Ref. Quote: 3112 / Date: 10/6/2026 / Rev 1

Project: **Sunrise Rye Brook - Independent Living / Assisted Living**

Mechanical drawings dated: 07.15.2026 (GMP set)

Mechanical Value Engineering Proposals

M5000 Hydronic flow diagram - boiler room

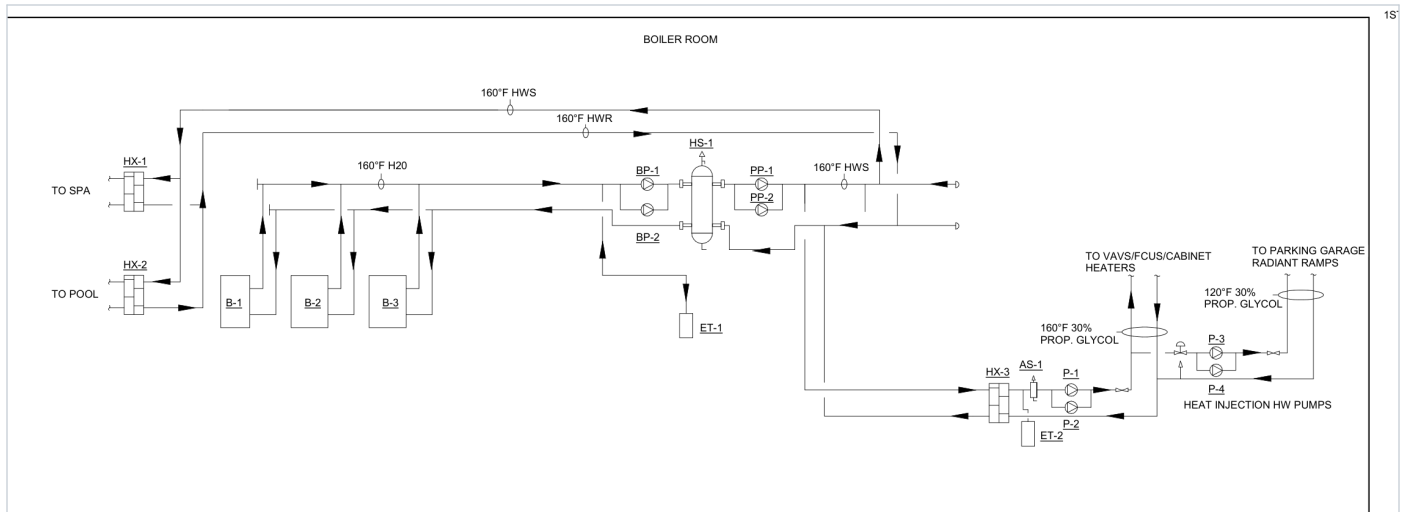
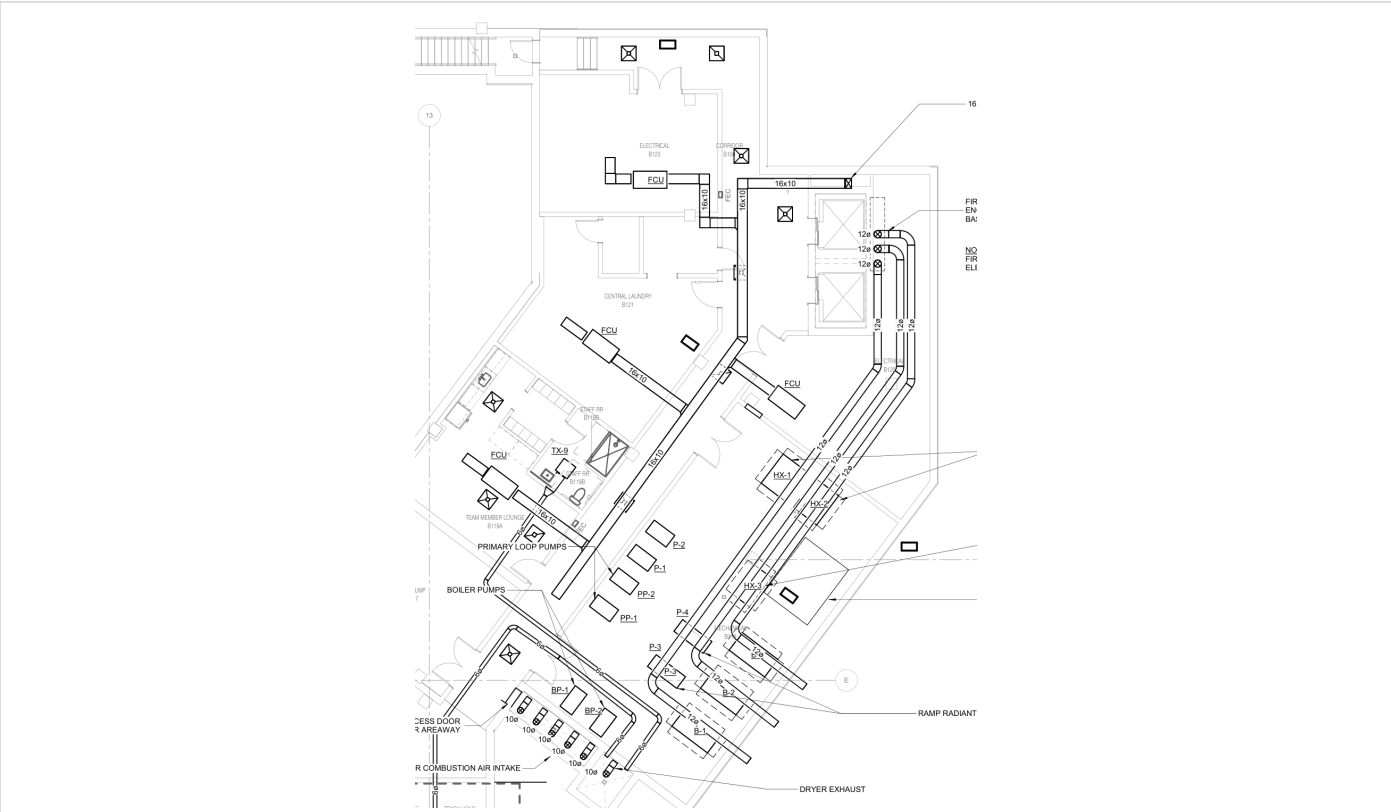
- Three 1,999 MBH gas boilers B-1, B-2, B-3 (5,700 MBH output), primary / secondary with HS-1
- Pumps BP-1/2, PP-1/2, P-1 to P-4, expansion tanks ET-1/2, air separator AS-1, heat exchanger HX-3 to 30% glycol
- Fire-rated chimney enclosures basement to roof, combustion air areaway, water treatment, hot water and glycol distribution to the 1st floor and basement
- Connected heating load about 2,430 MBH: the plant is about 2.3 times the load

- Delete the boiler plant and all hot water / glycol distribution; the building runs on gas rooftop units, heat pump DOAS and the electric terminal heat in VE-02 to VE-06
- No boiler room equipment, chimneys, combustion air, water treatment, flushing or hydronic balancing
- Pool and spa heating by the pool contractor (by others)

Mark-up M2010 IL area A - reception / lounge / bistro and offices

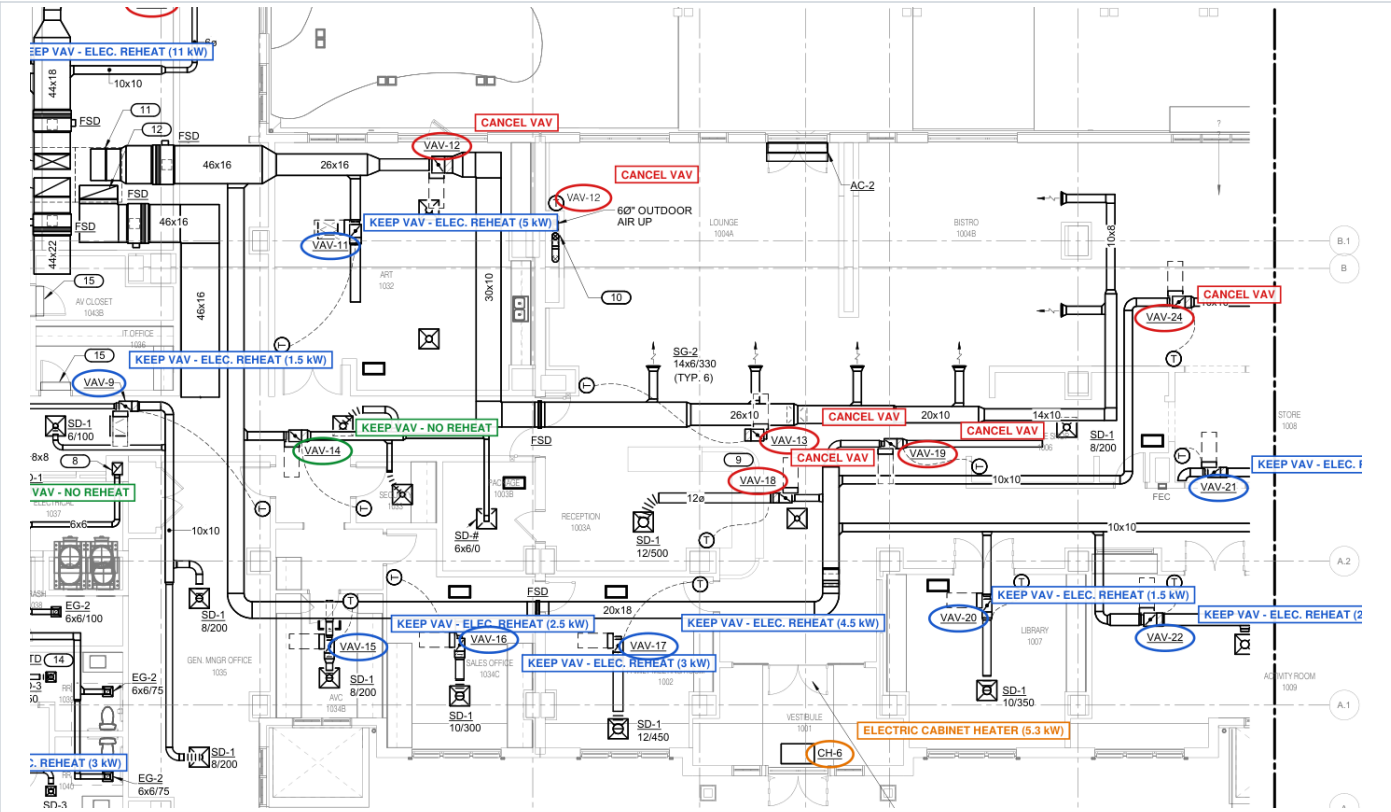
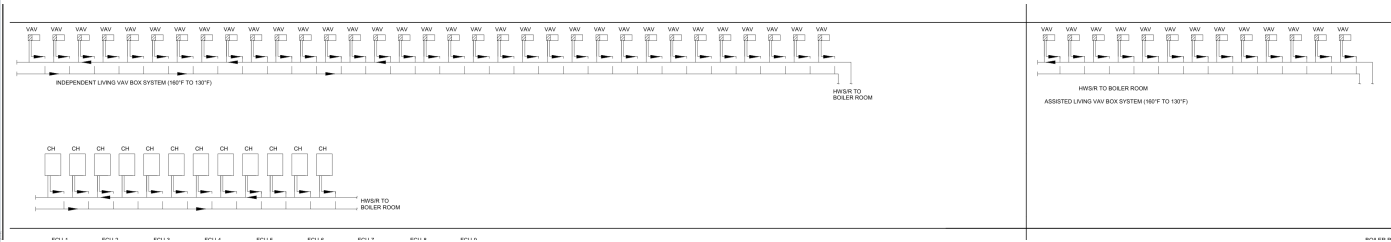
- 47 VAV boxes with hot water reheat coils (629 MBH, 45 GPM) on 5 rooftop units
- Hot water piping, control valves, balancing and insulation to every box (M2014 to M2016)

- Same rooftop units as designed (gas heat). VAV boxes kept in enclosed rooms (VE-03) get factory electric reheat coils with SCR control and a simple standalone thermostat: 25 boxes
- Interior / back-of-house rooms: VAV box kept cooling-only, no reheat required since the rooftop units are gas heat (VAV-8, VAV-14, VAV-31, VAV-32)
- No hot water piping, coil packages or control valves at any box. See mark-ups M2010, M2011, M2013

Mark-up M2010 IL area A - multi-purpose, theater, salon, offices, corridor

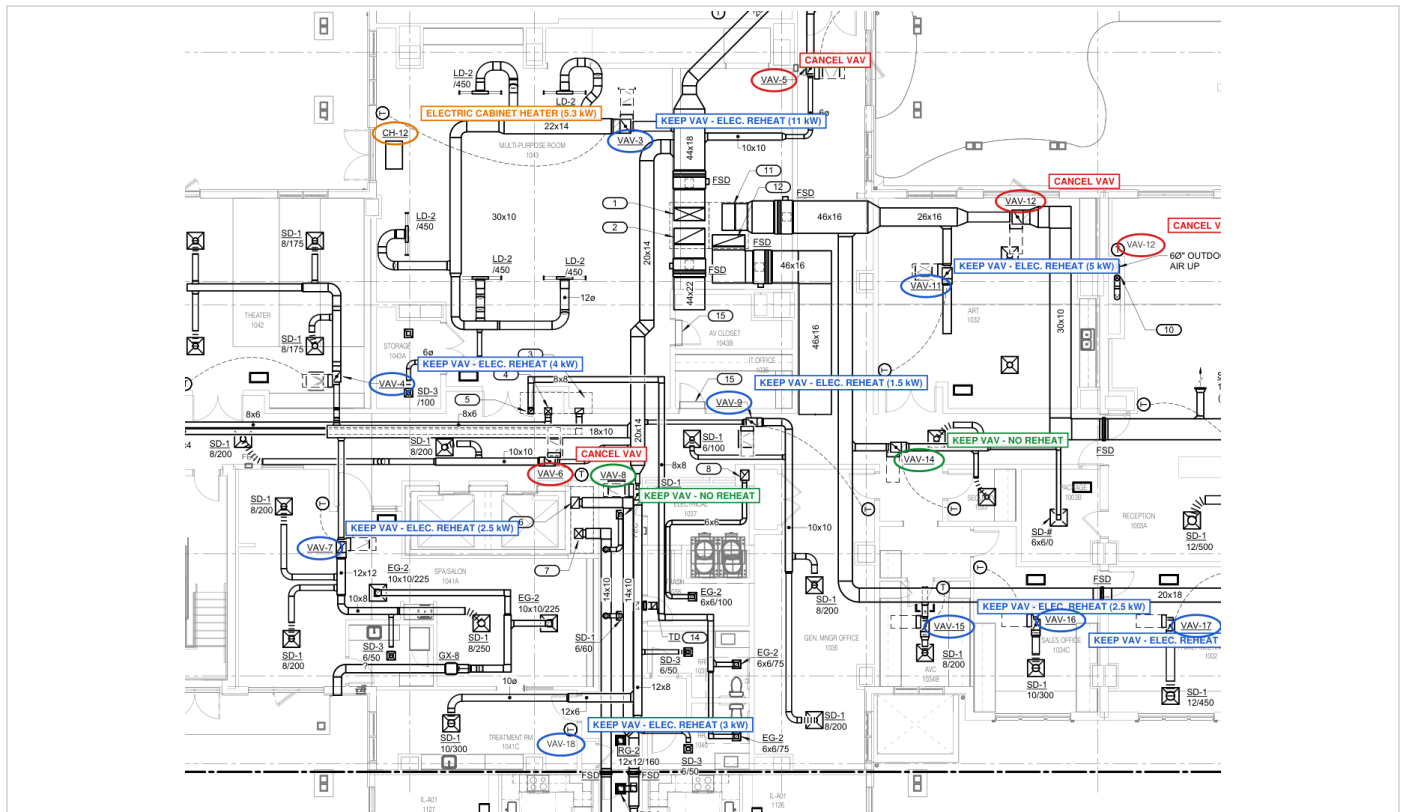
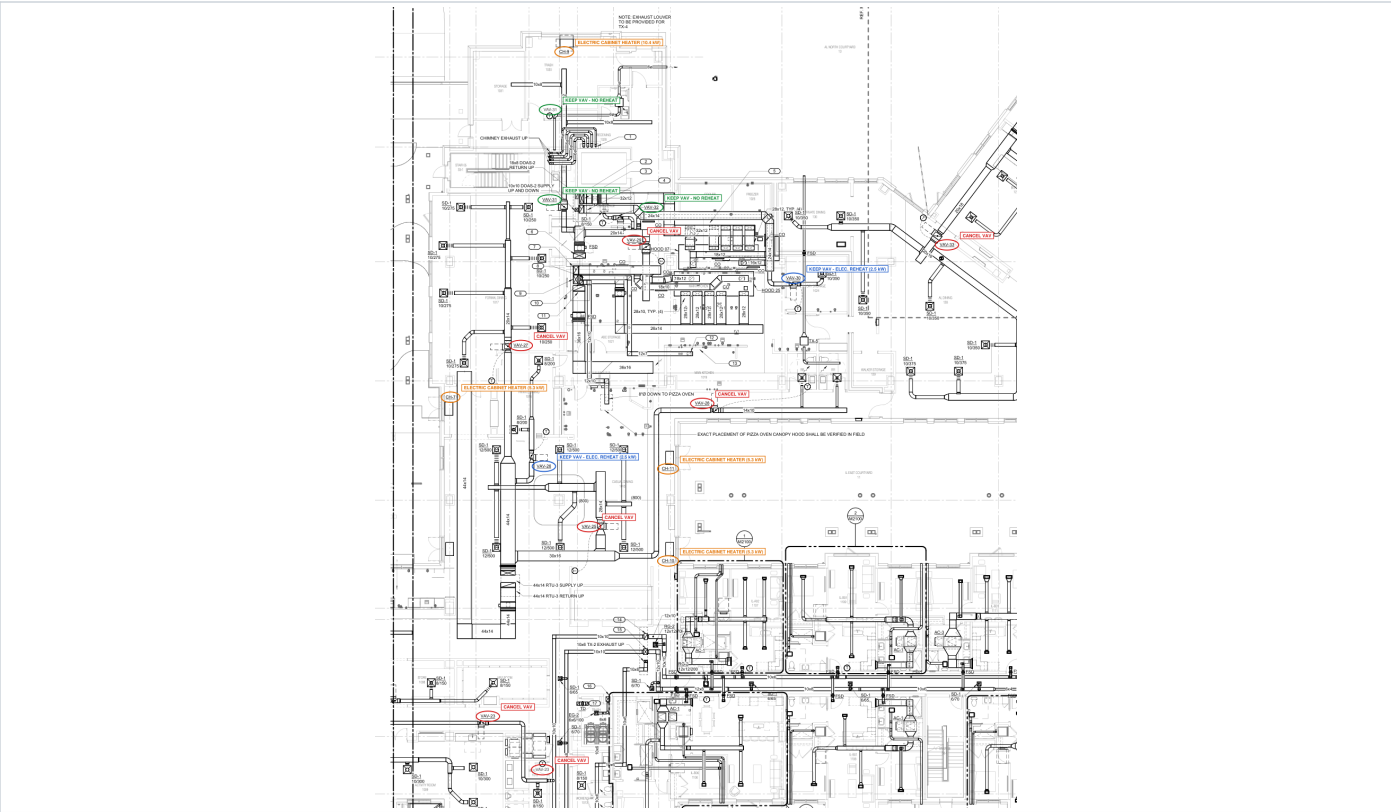
- 47 VAV zones on 5 rooftop units, including open areas that are one space with their neighbors

- Same rooftop units and main ductwork as designed. Cancel 18 VAV boxes in open areas and circulation (lounge, bistro, coffee shop, reception, formal / casual / AL dining, parlor, kitchen, corridors, restrooms)
- Branch ducts stay, with manual volume dampers balanced to the design maximum CFM; the area is served directly by its rooftop unit (rooftop unit space sensor in that area), gas heat from the rooftop unit
- VAV boxes stay only in enclosed rooms (offices, theaters, activity, fitness, salon, private dining, library, family rooms) - see VE-02. No ductless units added

- Each box is marked on the attached mark-ups: CANCEL VAV / KEEP VAV - ELEC. REHEAT / KEEP VAV - NO REHEAT

Mark-up M2010 - CH-12 and other entries

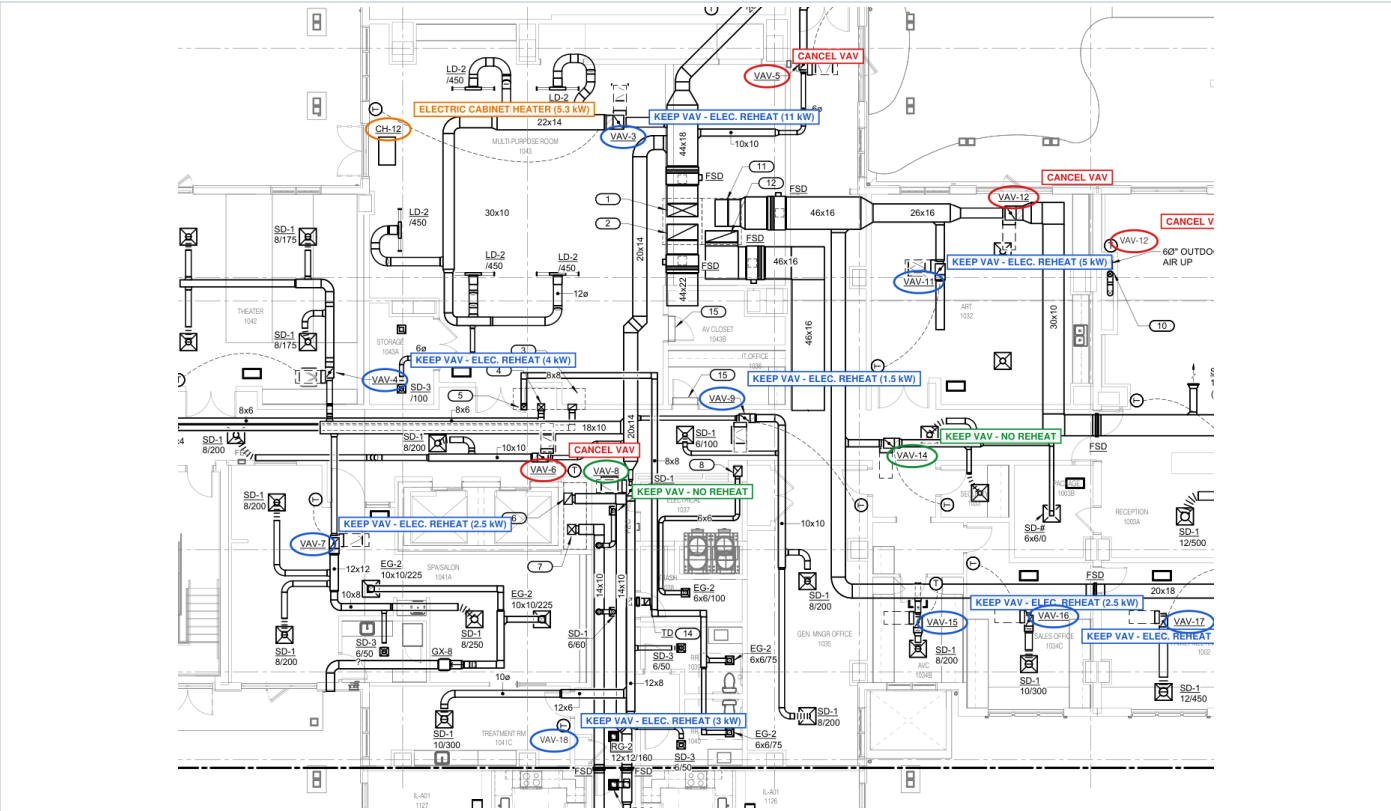
- 11 hot water cabinet heaters in the schedule (CH-8 not shown on plans) with piping and BMS control

- Electric cabinet heaters with integral thermostats at the same locations; no piping, no BMS points. Each heater is marked on mark-ups M2010 and M2011

Mark-up M2002 AL basement - storage, corridor, staff lounge, mechanical, electrical, laundry

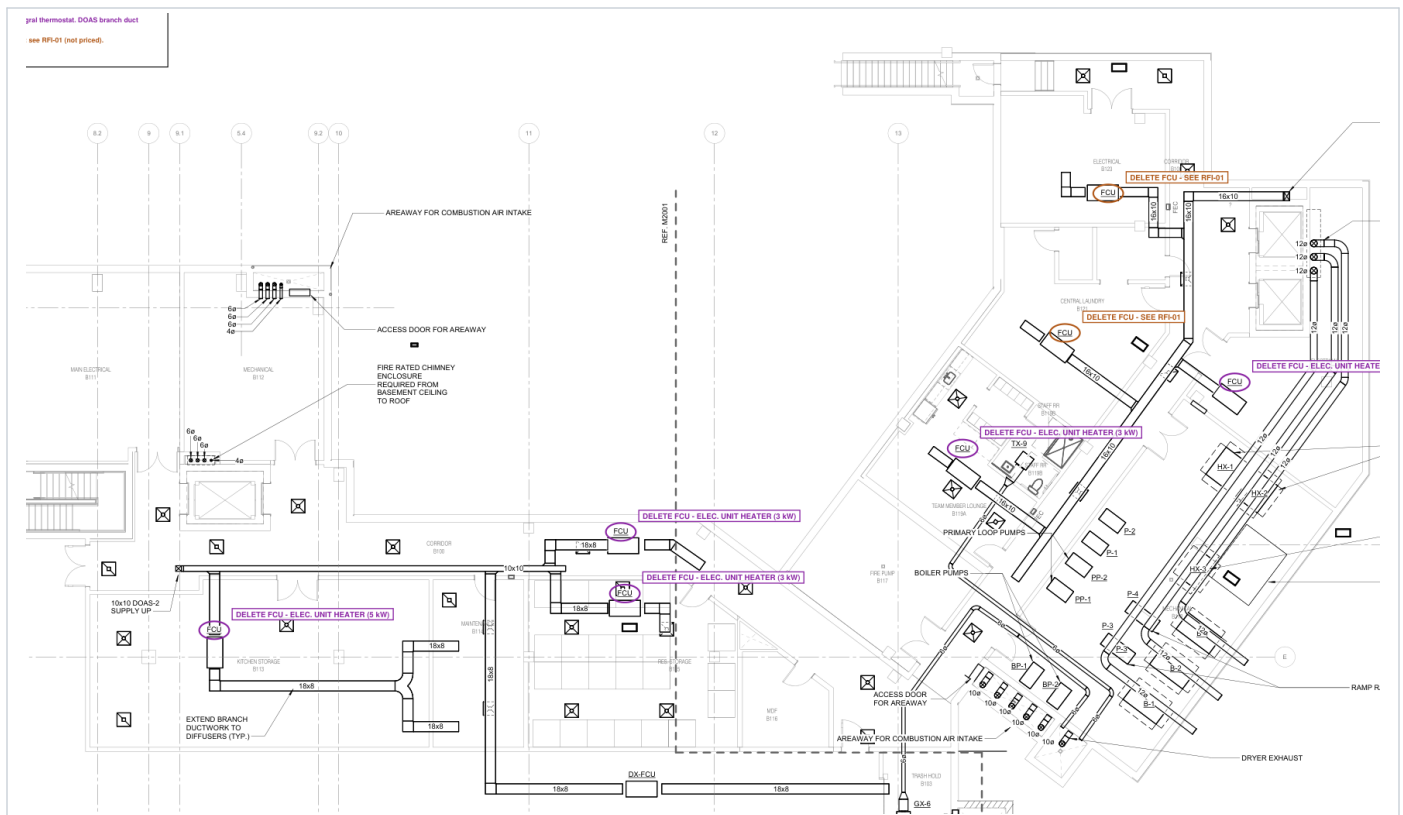
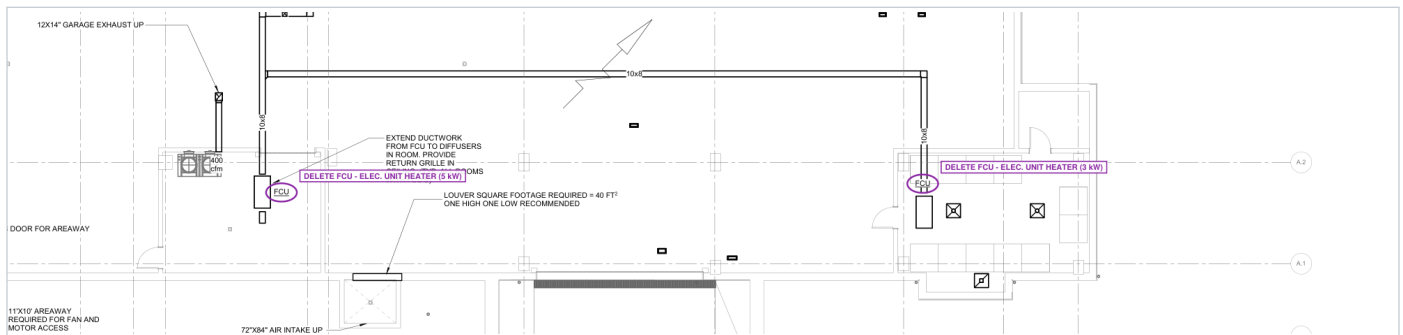
- FCU-A, quantity 20, "basement heating", hot water / glycol heating coil only (schedule data blank); M5000 shows FCU-1 to FCU-17 on the glycol loop with RAD-1/2
- Each FCU takes a small DOAS branch at its inlet and recirculates the room
- No glycol or hot water piping to these units is drawn on M2001 / M2003

- Delete the FCUs and RAD-1/2. Electric unit heater with integral thermostat in each room that had an FCU (storage, trash, corridor, staff lounge, mechanical); DOAS branch duct extended directly to the room diffuser, return grille deleted. Each unit is marked on mark-ups M2000 and M2002
- Electrical room B123 and central laundry B121: FCU deleted; these rooms need cooling / ventilation, not heat - see RFI-01 (separate page, not priced)

M5000 Hydronic flow diagram - basement FCUs, RAD-1/2 and ramp snow melt loops

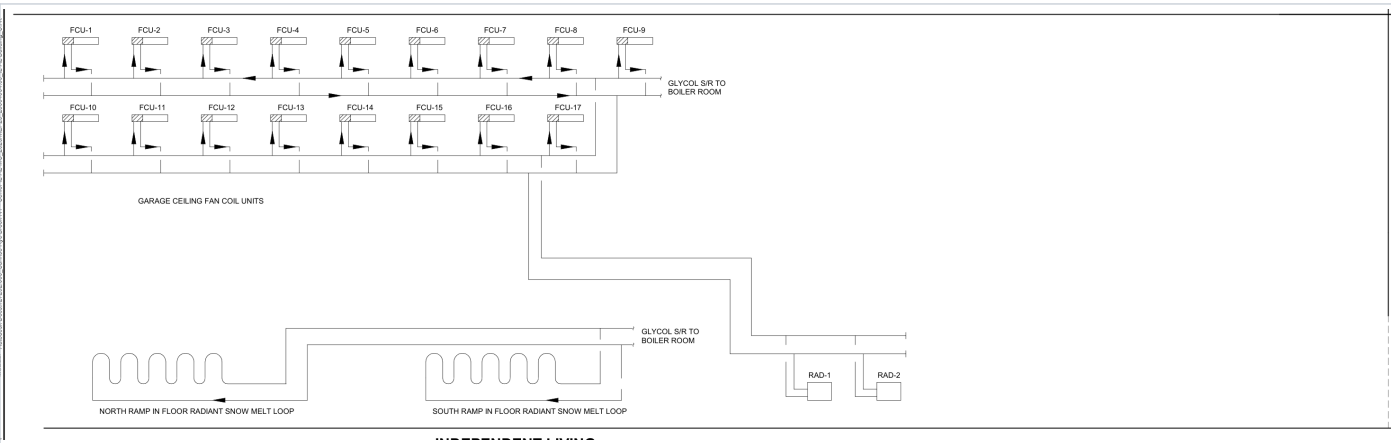
- In-floor radiant snow melt loops on both ramps from the boiler plant through HX-3

- Option A: no snow melt; trench drains and salting (owner decision)
 - Option B: electric snow melt cable by EC, storm-only operation with load shedding
- Benefits: Removes the long glycol mains from the boiler room to the ramps and the snow melt pumps.
